**City of Ryde Submission**  
**4-14 Terry Road & 127 - 133**  
**Ryedale Road, Denistone**

## City of Ryde Submission

## **INDEPENDENT REVIEW BY RYDE URBAN DESIGN REVIEW PANEL**

## Urban Design Review

Figure 2. Proposed blanket FSR across the whole site is inappropriate (Adopted from site plan by Turner Hughes Architects)

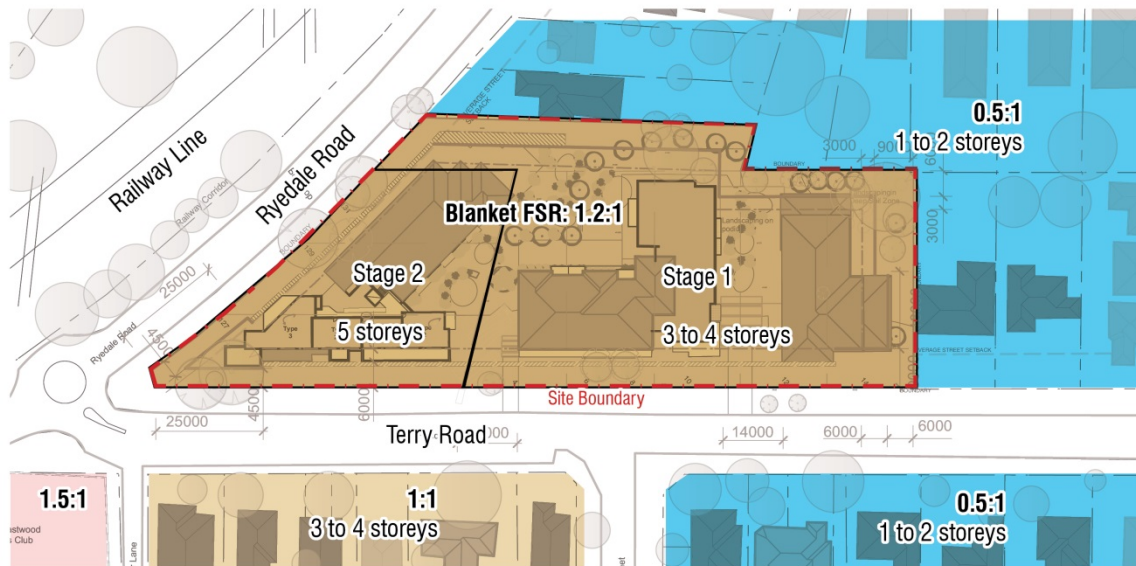
The proposed height strategy responds to the sloping topography of the site by having greater building heights (up to 5 storeys) on the west and lower building heights (3 to 4 storeys) on the east of the subject site. Following this approach, the development will result in different levels of floor space distributed in Stage 1 and Stage 2 areas. Applying a blanket FSR control across the whole site will not be appropriate as it does not align with the strategy to provide transition in building heights, scale and density (see Figure 2).

Figure 3. Stage-specific FSRs required by Council

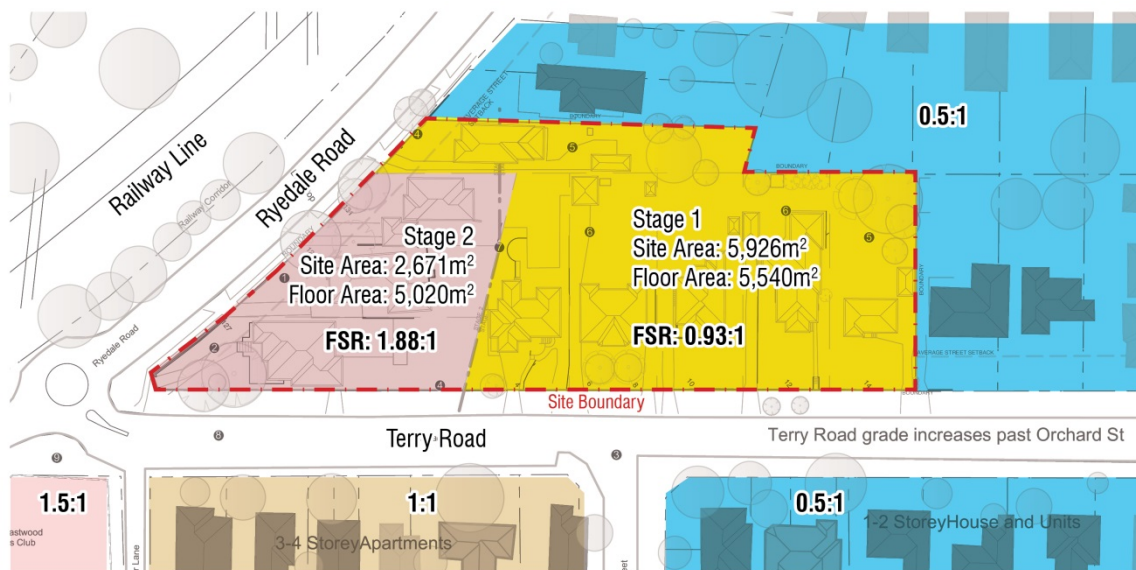
Based on the latest concept plan dated 10 May 2019, the proposal contains a total floor space of 10,560m<sup>2</sup>. Stage 1 with lower building heights and more open space will achieve floor space of 5,540m<sup>2</sup> (equivalent to an FSR of 0.93:1), as demonstrated by Concept Drawing 293 PP21 L by Turner Hughes Architects. The remaining 5,020m<sup>2</sup> will be delivered at Stage 2, achieving an FSR up to 1.88:1 (see Figure 3).

Although the Planning Proposal does not seek to amend any maps within the Ryde LEP and only relies on 'Additional Local Provisions' under Part 6 of the Ryde LEP to achieve the proposed development, it is City of Ryde's position that a stage-specific FSR map is necessary to stipulate the distribution of floor space across the two stages of development.

Should a blanket FSR control be applied, it will lead to an inappropriate distribution of floor space and likely encourage an overdevelopment at Stage 1. As a result, it will undermine key design principles of the design concept, such as maintaining a sensitive relationship with the low-scale residential properties, gradual increase of heights/density towards the Town Centre and retaining generous deep soil planting areas adjacent to neighbouring properties. Such an outcome is unacceptable and should be addressed prior to a Gateway Determination.

- The blanket FSR of 1.2:1 is replaced by stage-specific floor space ratios – 0.93:1 for Stage 1 and 1.88:1 for Stage 2. The FSRs are subject to the final floor space calculation for the amended Planning Proposal in response to the UDRP comments.
- A stage-specific FSR map, similar to Figure 3 of this submission, is included under Part 6 'Additional Local Provisions' of the LEP.
- The site-specific DCP and Concept Plan should be amended as per comments provided to the Applicant on 29 April 2020.

**Figure 4. Council advising side setback changes required (Adopted from Site Setback Diagram by Turner Hughes Architects)**

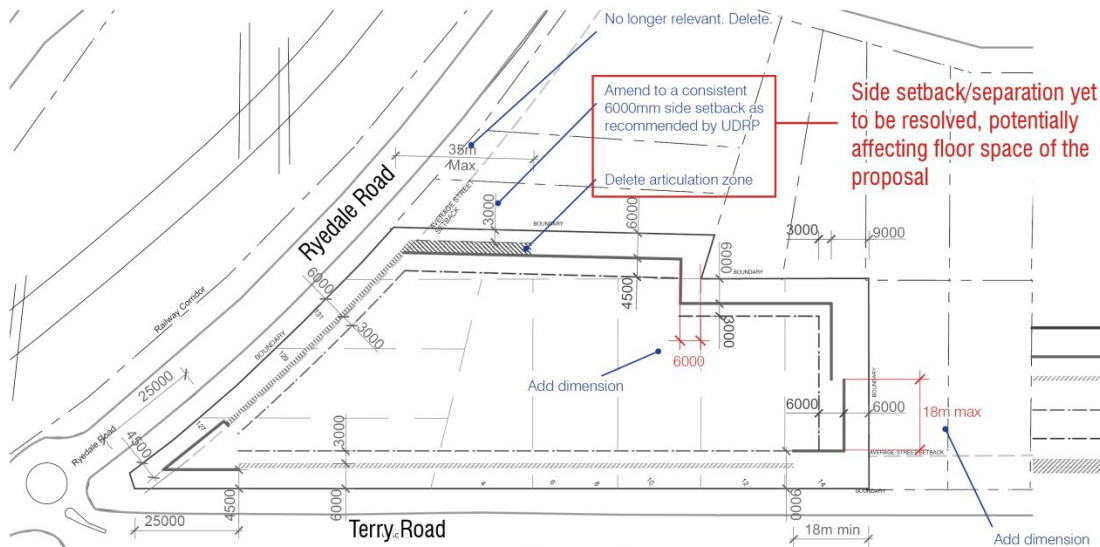
The proposal provides a 3m setback for a depth of 38m from the front boundary along the north-west boundary to 135 Ryedale Road - an existing 2 storey dwelling house. The concept design shows a stepped building form which notionally increases the area of landscape between properties. It is the UDRP's opinion that the stepped form combined with the angled frontages of existing houses increases the perceived building bulk along Ryedale Road from the north. There is also nothing in the DCP which requires a stepped profile and prevents a building from aligning with the 3m setback.

The UDRP advises that increasing the side setback to 6m with tree planting along the boundary will provide a better form. The increased side setback zone with landscaping will assist with screening and mediating between the two scales (house and apartment) and different street setbacks (existing houses at an angle to the Street and a street edge aligned building for the proposal). This would reinforce the landscape character of the neighbourhood, assist in transitioning between the new building form and existing houses; and reduce apparent bulk when viewed along Ryedale Street from the north. However, the proposal has not responded appropriately to this recommendation despite Council's feedback (see Figure 4).

**Figure 5. Concept plan design self-conflicting with DCP control draft by Applicant (Adopted from Terry Road Elevation by Turner Hughes Architects)**

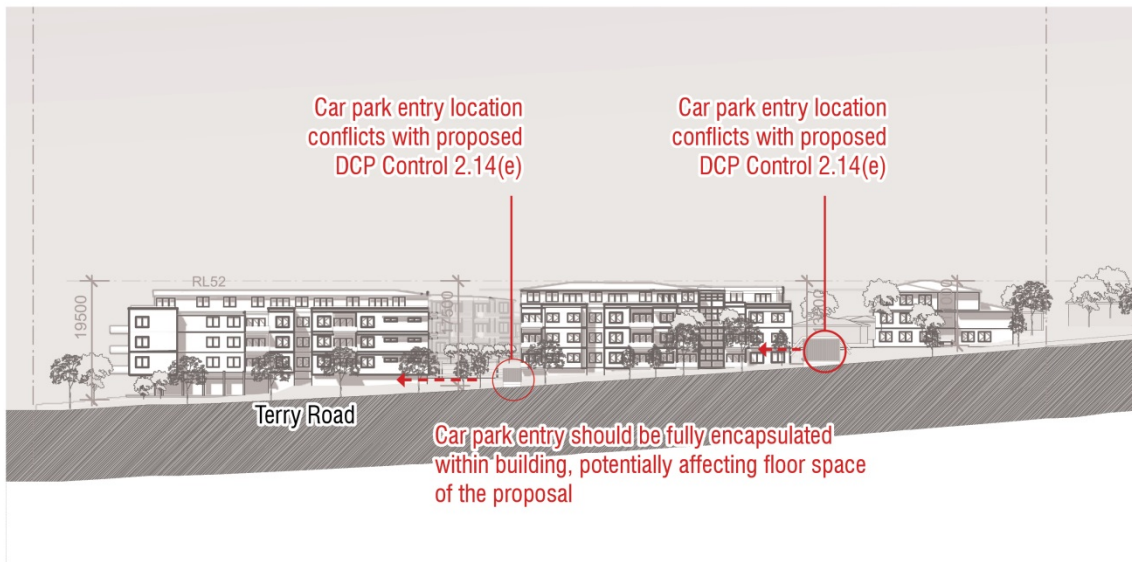
The UDRP is concerned that the driveways will be visually dominant along the street and out of character with the existing context. Landscape between buildings is more appropriate to the residential character of the area and helps to reduce the bulk and scale of the new buildings. A DCP control was provided in 2.14(e) - “car park entry ramps are to be encapsulated within the building.” However, this design approach is not reflected in the Concept Plan, which still shows car park entry ramps located between building forms (see Figure 5).

Therefore, amendments are required to better address the interface with the public domain and respond to the UDRP recommendations. By integrating the car park entry into the building form, it is likely to replace some ground floor units and as a result floor space of the proposal might be reduced.

Figure 2 Terry Road Elevation

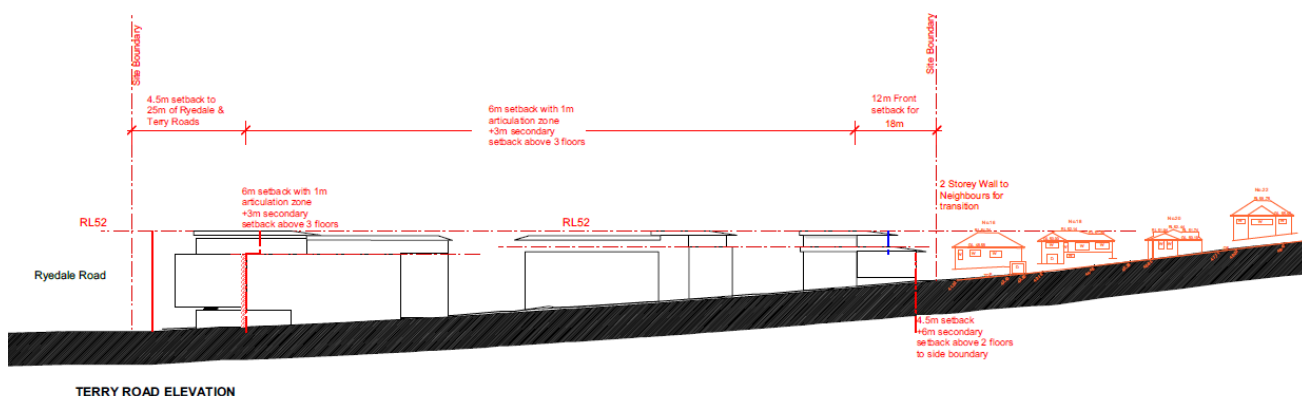
Figure 2 - It should be updated to reflect the proposed 9m front setback for a minimum of 18m adjacent to No.16 Terry Road. The side setback should also be updated to reflect the proposed 6m side setback and a further 6m upper-level side setback to No.16 Terry Road.

Control 2.4(b) - Revise to "The height and scale of the development are to be modulated to provide for an appropriate built form transition to the adjoining residential properties along Terry Road by incorporating side setbacks and upper-level setbacks as depicted in Figure 2."

Control 2.4(c) - Revise to "Provide a built form that transitions with the topography of the land and streetscape to ensure lower buildings heights to the north and east of the site, adjacent to the nearby low-density residential dwellings as depicted in Figure 2."

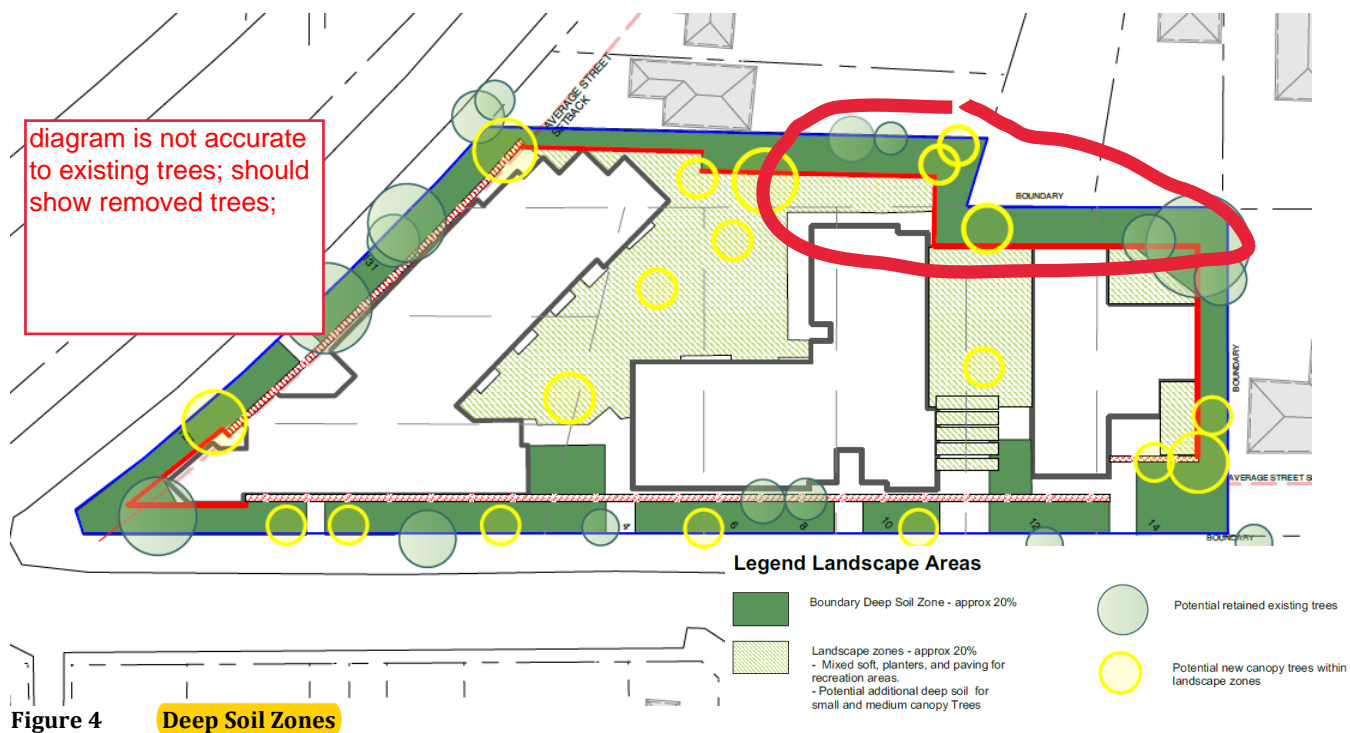
Figure 3 - indicate deep soil zone and landscape planting in the street setback zone to reflect the new objective 2.5(4) above.

Control (b)(ii) - inconsistent with the setback plan. Should be rectified to: "For a minimum of 18 metres from the boundary with 16 Terry Road, the development will be setback 9 metres from the street."

### **Concept drawings:**

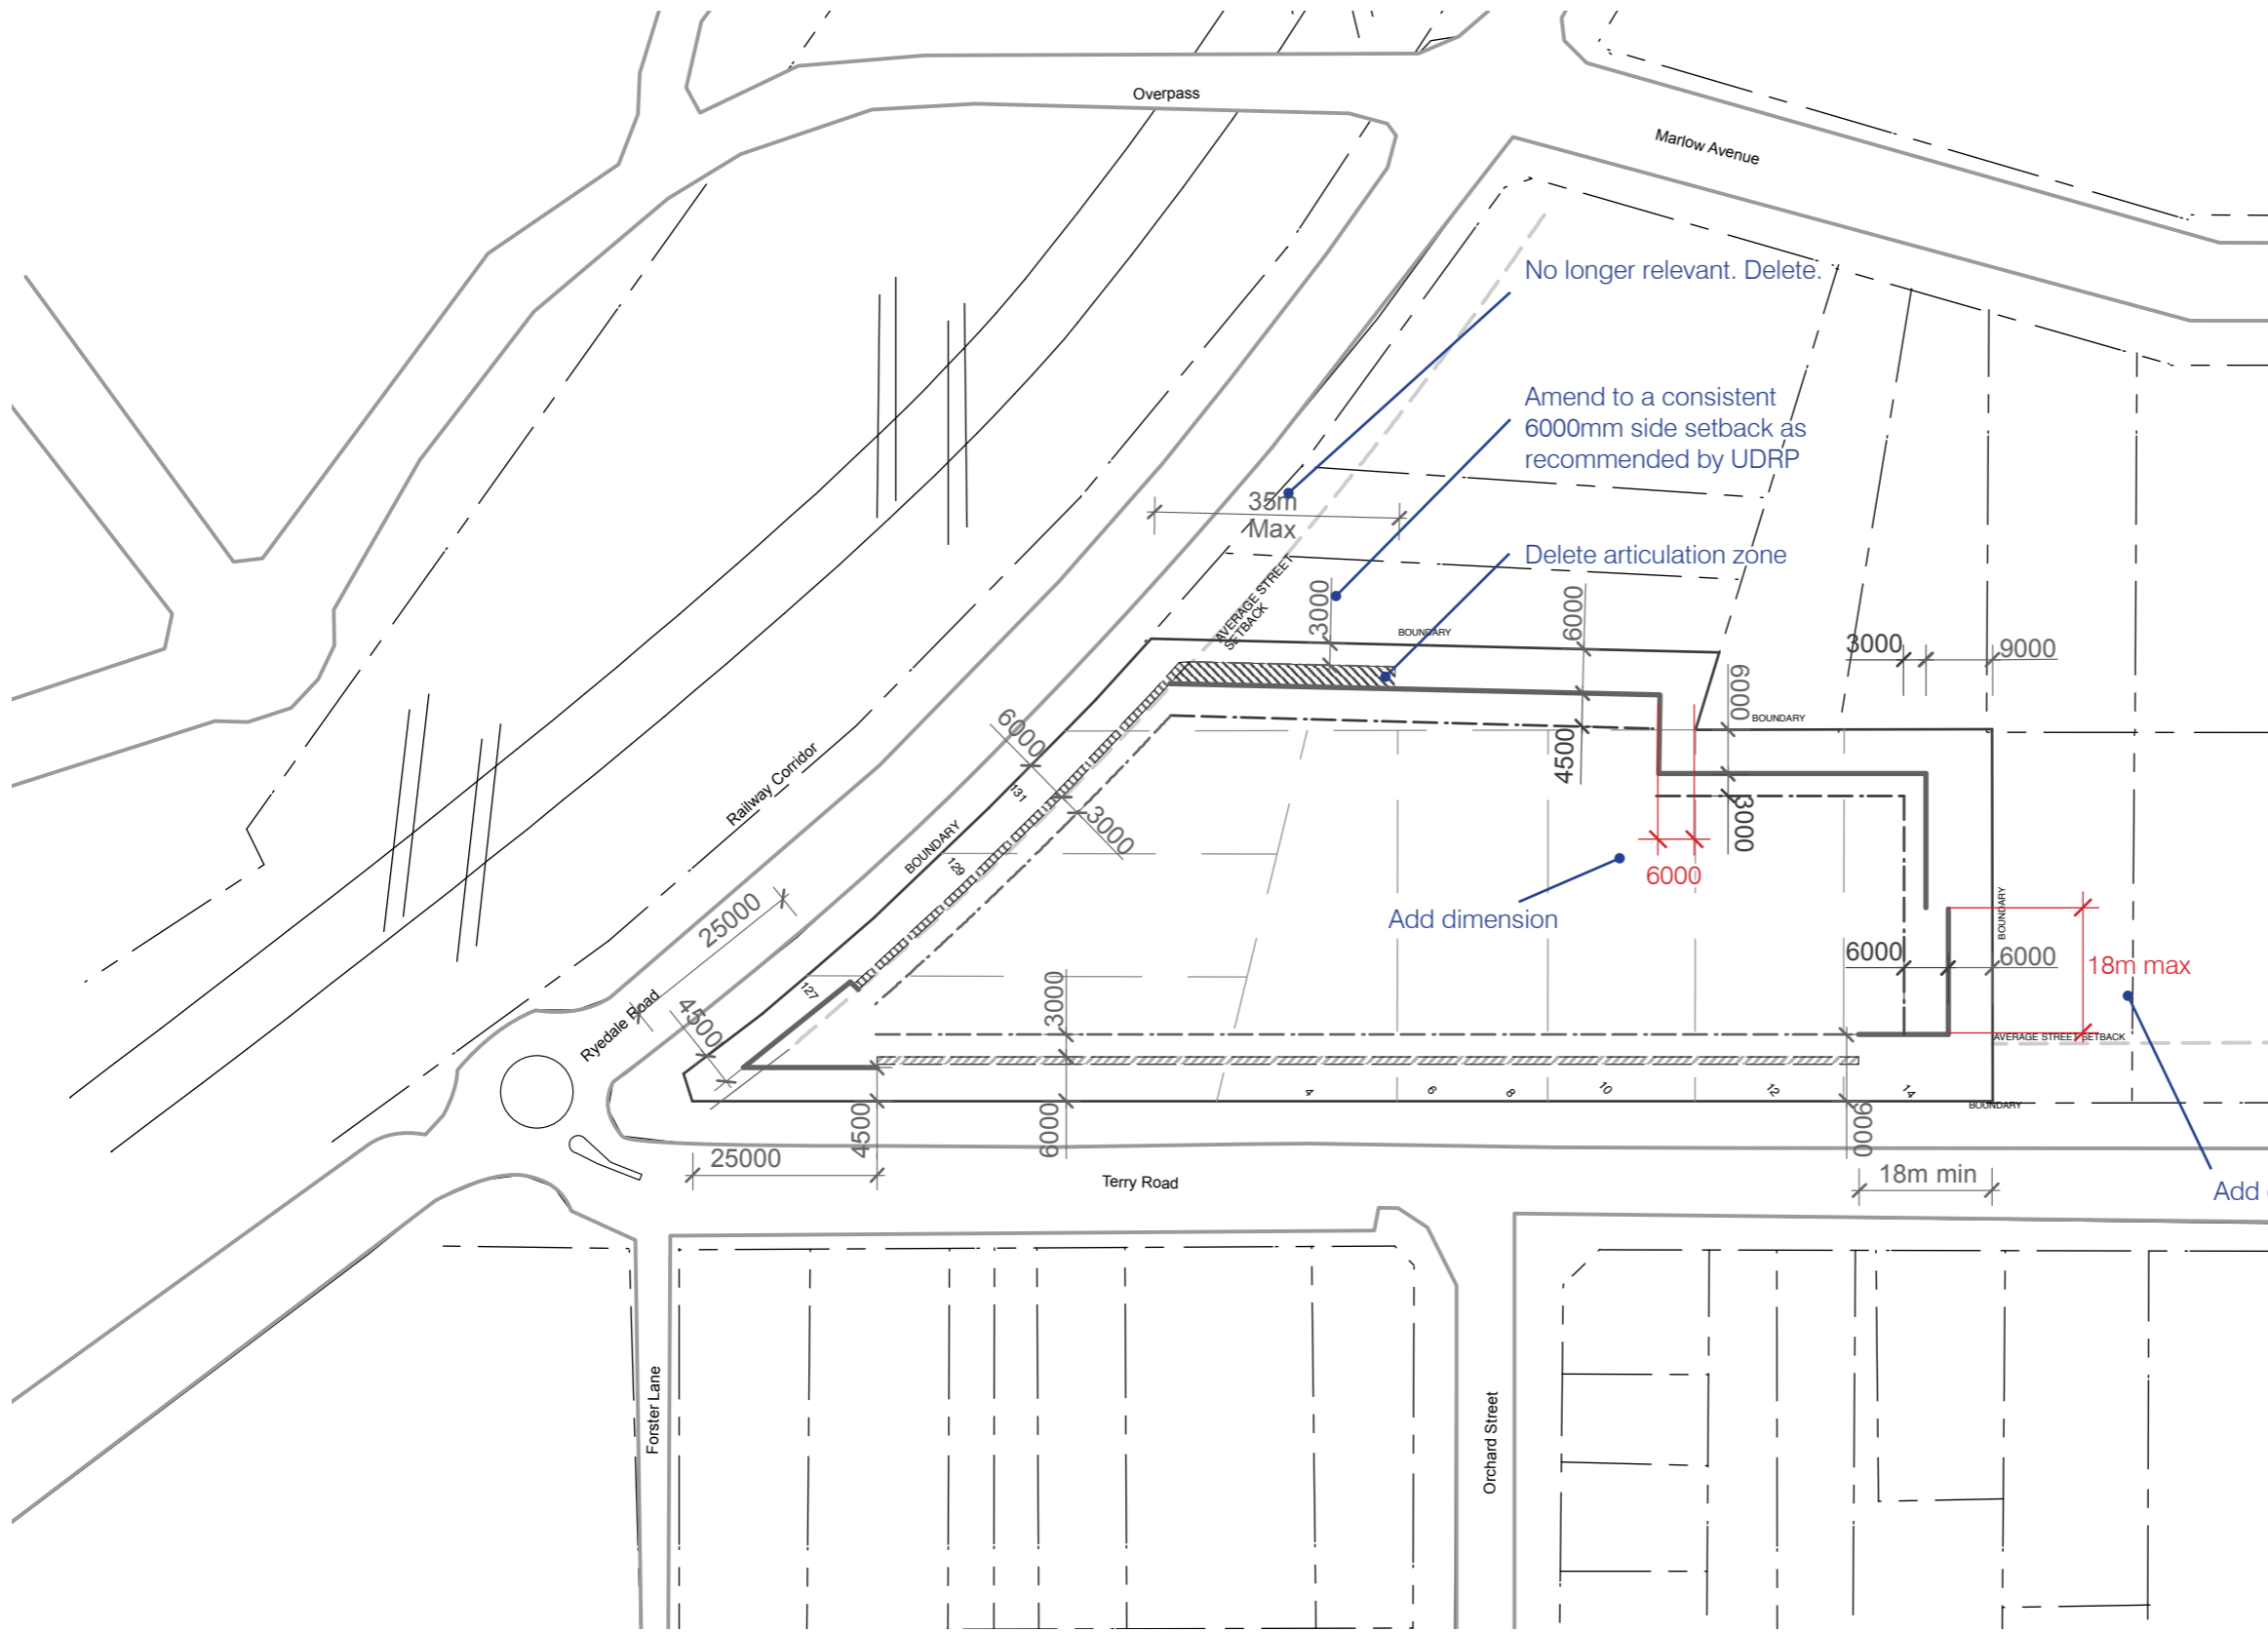
The following comments are in relation to the architectural concept package. The Concept design is to be amended to reflect the updated site-specific DCP Controls, including:

- Encapsulate car park entry ramps within the building form to comply with Control 2.14(e).
- adjust side setback to No.135 Ryedale Road, as recommended in the PDF attached.
- Rectify side setback to 16 Terry Road in Drawing 293 PP08 K - the 4.5m setback is inconsistent with the 6m setback indicated in the Urbis' written document and the setback plan.
- Update the FSR calculation to reflect the revised building envelop.
